AMENDED PLAN
Ref.
SOUTH HOLLAND DC
HOUSING & PLANNING
15 OCT 1998
Ref: 0658/98

B - GEN ALTS - 1.10.98
A - B.C. - BUTT - 9.9.98

PROPOSED HOUSE & GARAGE AT BARLING DEER FARM, BARDLING DROVE, SUTTON ST. JAMES FOR

GROUND FLOOR PLAN

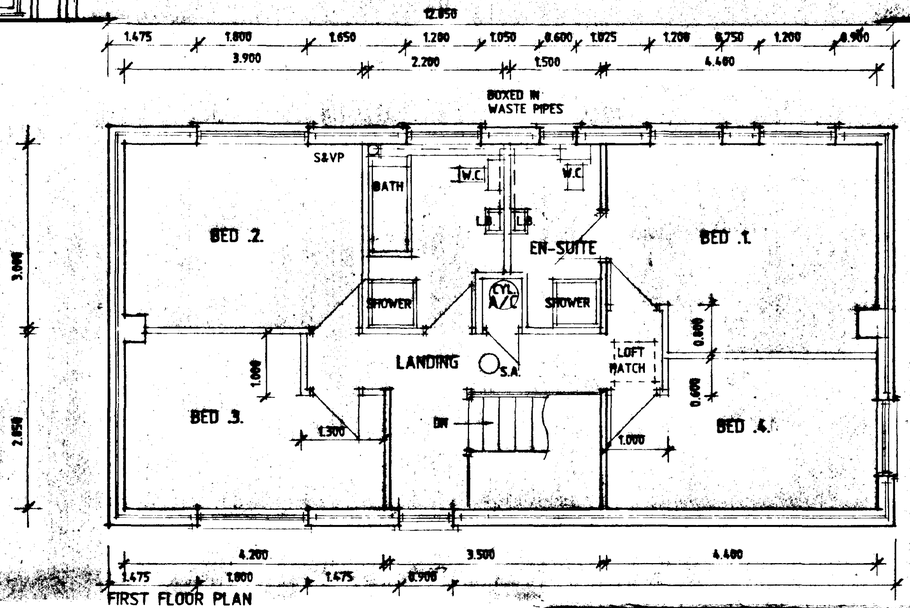
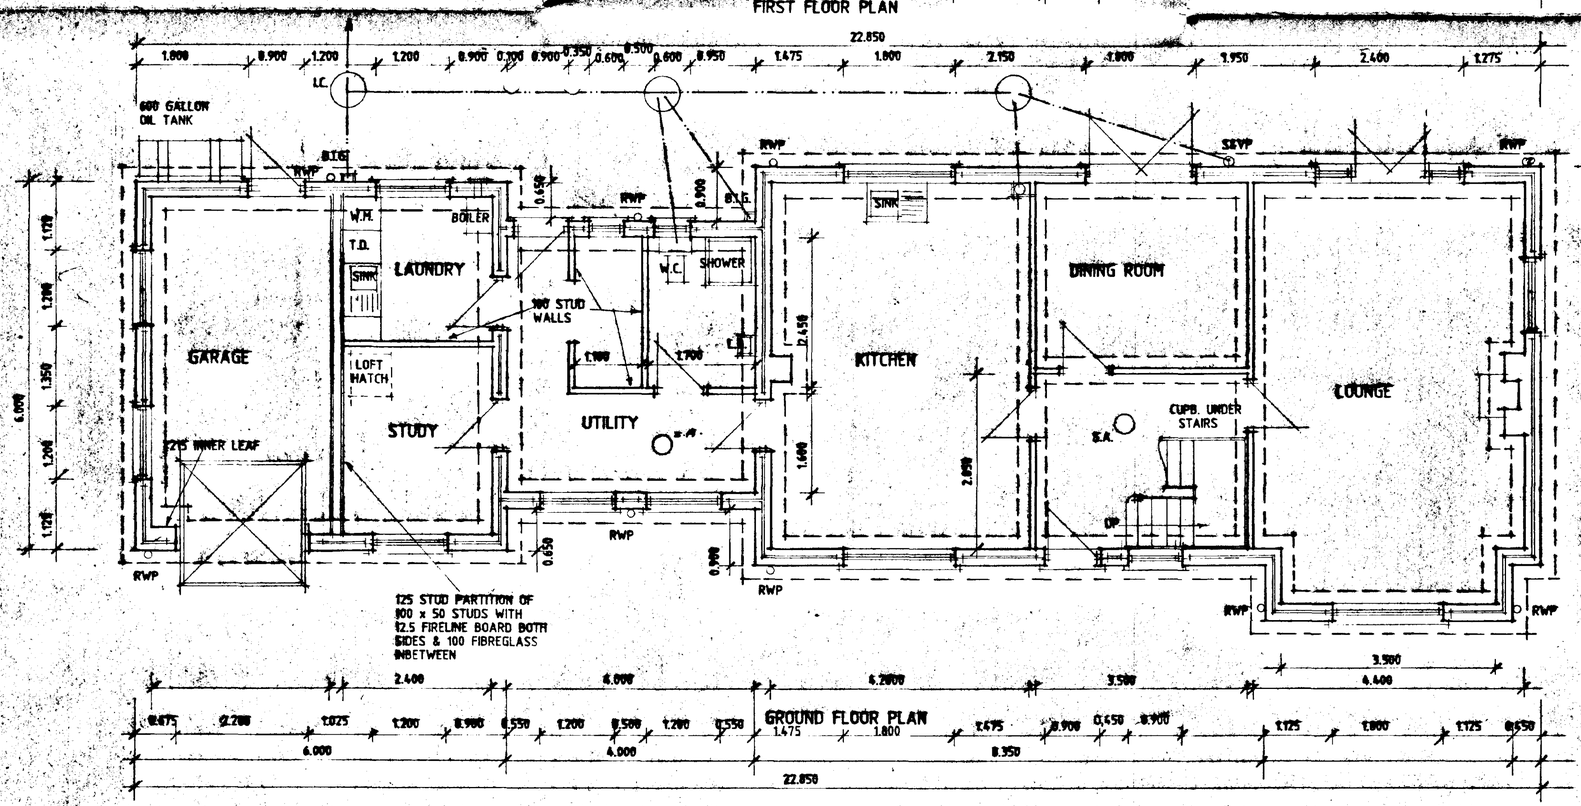
Provide a light switch next to door entry.

All smoke alarms to be interlinked.

Ensure study window has an escape window of minimum 450mm high x 500mm wide.

Ceiling to garage to give minimum ½ hour fire resistance.

Driveway to be minimum 3.0m wide and constructed to have a loading capacity of 12.5 tonnes.

Shower room ventilation as per bathroom.

Waste pipes to be minimum 38mm internal diameter.

GROUND FLOOR PLAN

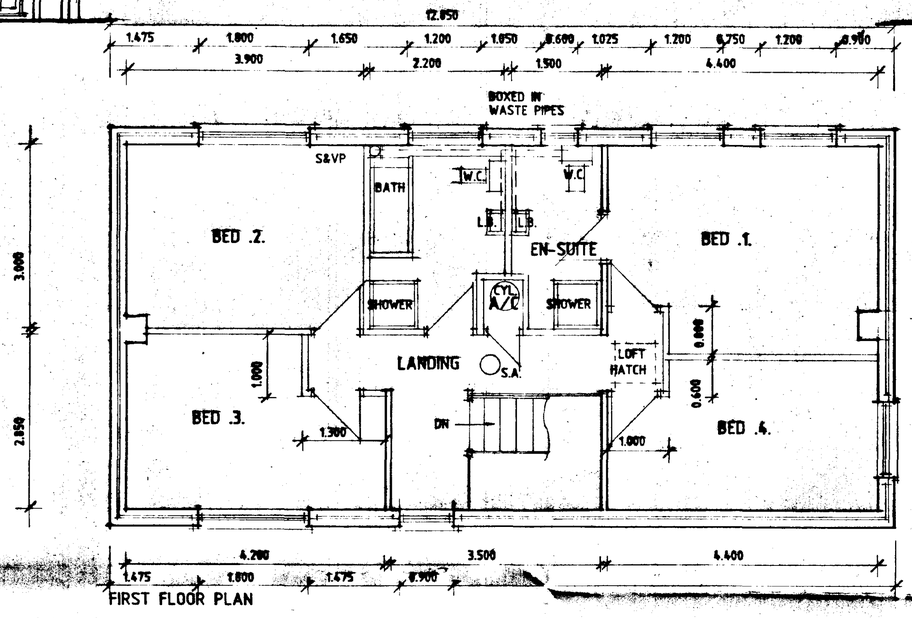
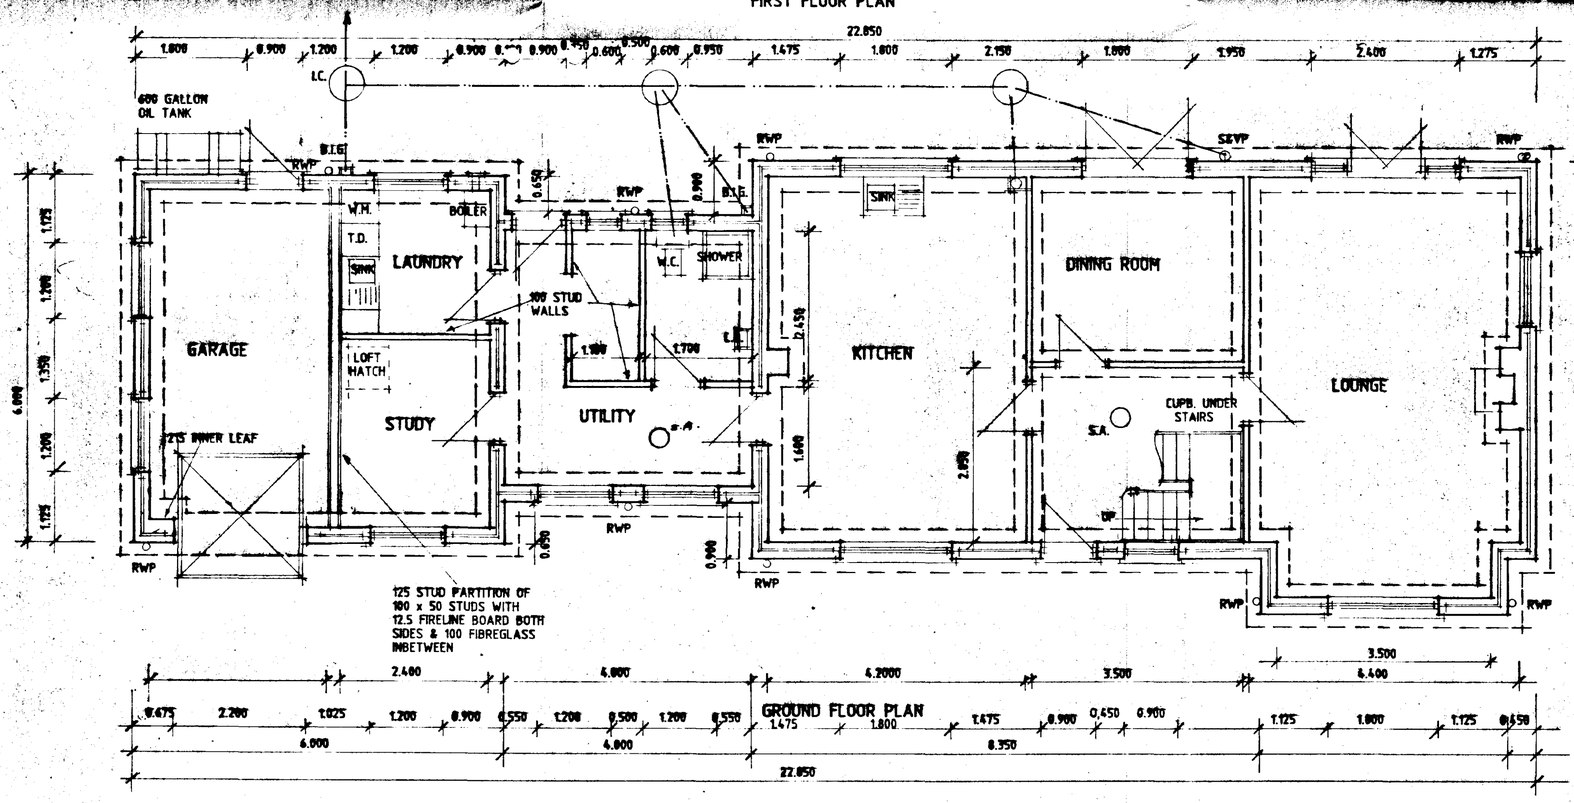
Provide a night switch/switch to floor above.

All smoke alarms to be interlinked.

Ensure study window has an escape window of minimum 450mm high x 500mm wide.

Cladding to garage to give minimum ½ hour fire resistance.

Driveway to be minimum 5.0m wide and constructed to have a loading capacity of 12.5 tonnes.

Shower room ventilation as per bathroom.

Waste pipes to be minimum 50mm internal diameter.
